Public Submission – State Significant Development Application No. SSD-47105958 at 24A Kingscliff Street, Kingscliff

This submission is made on behalf of concerned members of the local community. The submission relates to the proposed state significant development application (SSD-47105958 – *the Application*) for “seniors housing development providing for 120 bed residential care facility , 199 independent living units, ancillary amenities and landscaping” at 24A Kingscliff Street, Kingscliff (*the Subject Site*).

Figure 1 Basement Level 1

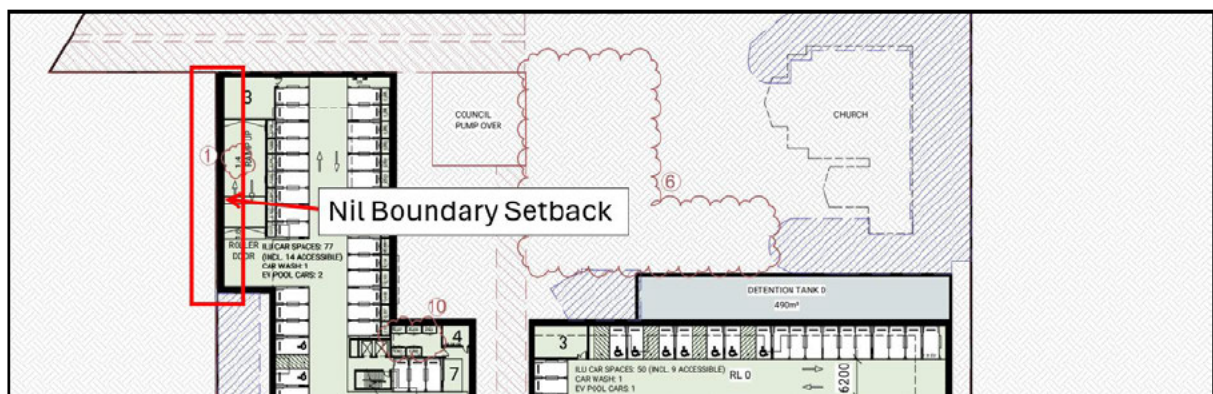
The proposed development incorporates a single basement level with nil boundary setbacks to No. 6 Beach Street (see figure below). This design necessitates substantial subterranean excavation along the site's shared property boundaries.

In light of the findings in *Al Maha Pty Ltd v Huajun Investments Pty Ltd*, the proposed development cannot lawfully be determined other than by refusal in the absence of owner's consent from adjoining landowners.

Accordingly, the Application should be refused on the basis that it fails to satisfy a fundamental legal prerequisite for determination – namely, the provision of written consent from affected adjoining landowners.

- Increase basement level setbacks from the common property boundary.
- Incorporate visual privacy screening measures (such as screens, fencing, angled louvres etc.) for upper-level windows and outdoor terraces for all buildings with direct sightlines onto neighbouring properties.
- Reduction in bulk and scale through the deletion of fourth storey from buildings B-G to enhance compatibility with surrounding low-density context.

Figure 2 Basement Construction Method (Geotechnical Report Extract)

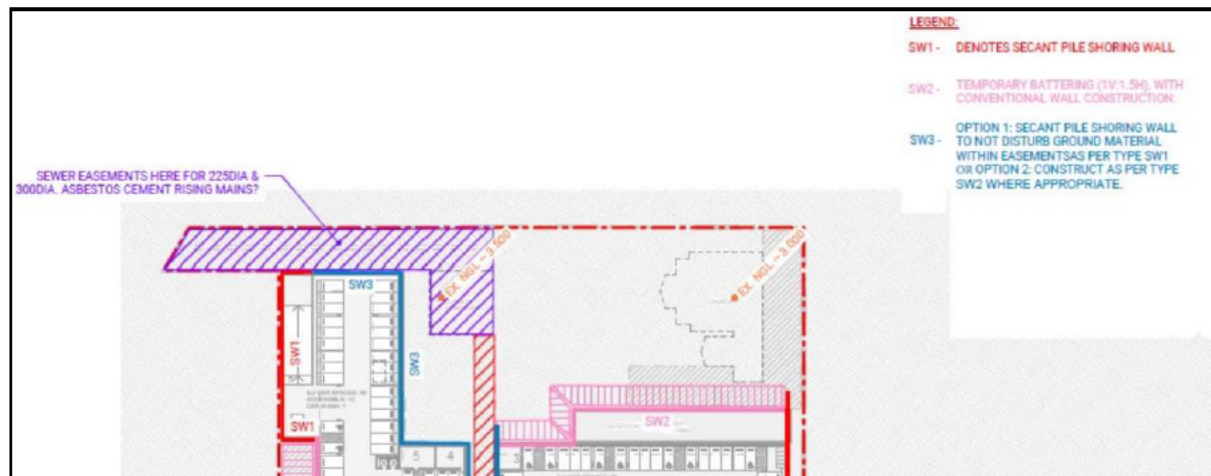
The Geotechnical Report accompanying the Application (Pacific Geotech Pty Ltd, dated 15 March 2024) identifies a secant pile shoring wall as the primary support system for the basement level adjacent to the northern boundary (p. 12, Figure 1 – see extract below).

Although the report does not explicitly confirm whether rock anchors or other horizontal drilling techniques will be employed to implement this support system, it does indicate that such methods are required for other support systems on the site, including those involving sheet piles (p. 11, Section 11). Accordingly, it is reasonable to infer that rock anchors may be used during excavation and construction of the secant pile shoring wall. If so, the development would require penetration into neighbouring land, triggering the need for adjoining landowners' consent to accompany the application.

Figure 4 Density Analysis

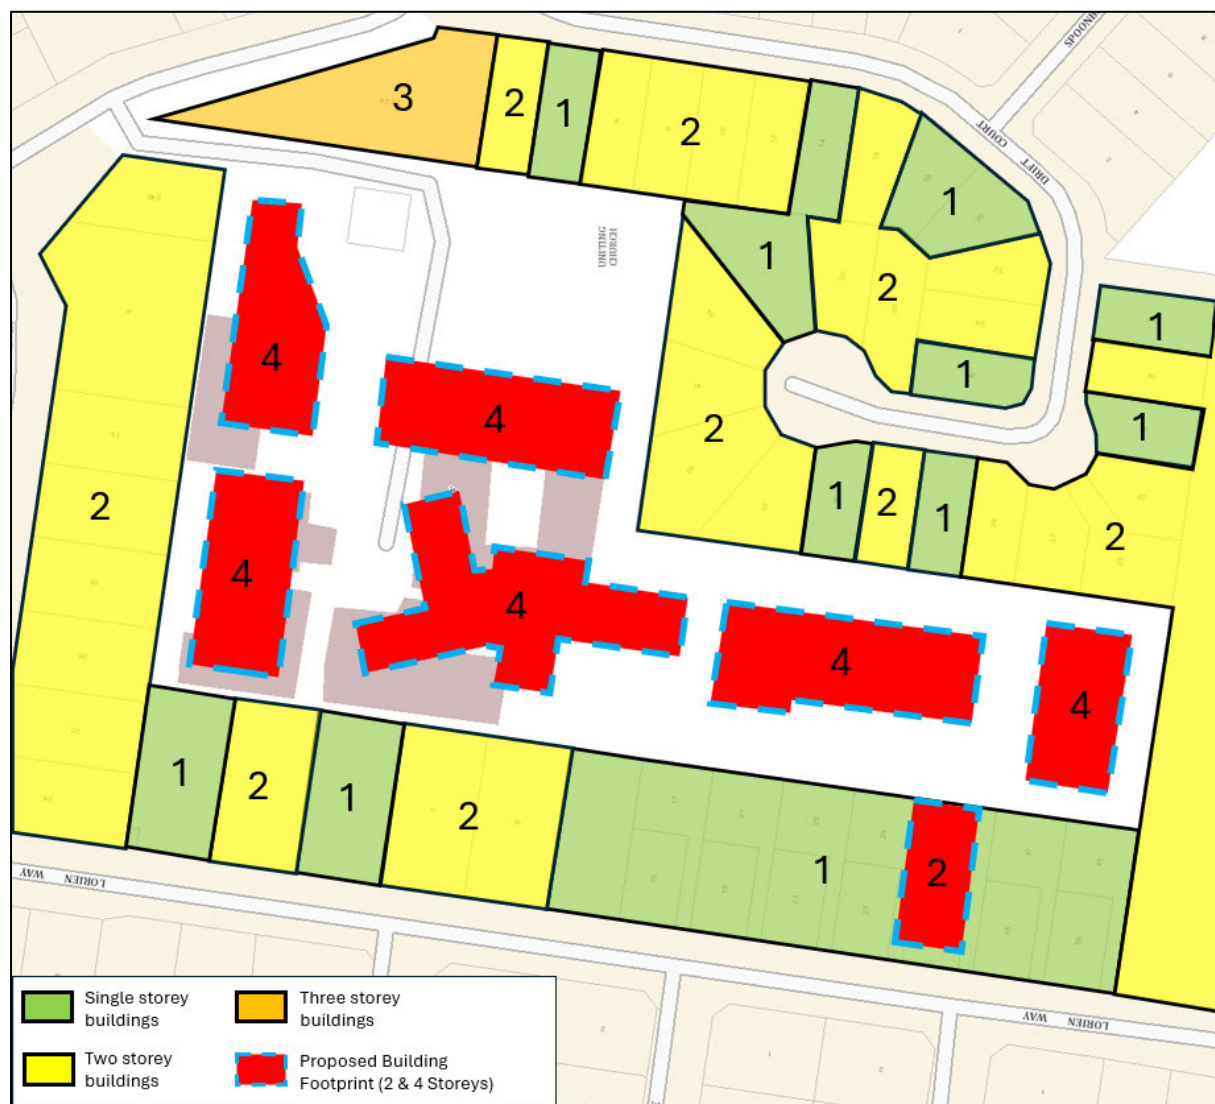
The proposed development's excessive height, bulk, and scale are fundamentally inconsistent with both the planning controls and the established low-density character of the locality. The Application seeks approval for a building height of 17.05m, representing a 25.36% variation above the 13.6m maximum prescribed by the Tweed Local Environmental Plan 2014. This significant non-compliance would intensify privacy, and amenity impacts for surrounding residents.

The prevailing character of the area—bounded by Beach Street, Lorien Way, Blue Jay Circuit, Drift Court, and Kingscliff Street—is defined by one- and two-storey dwellings, with only a single three-storey building at the intersection of Kingscliff and Beach Streets (see density analysis below). The proposed development would introduce a dramatic and abrupt increase in height, out of step with its context.
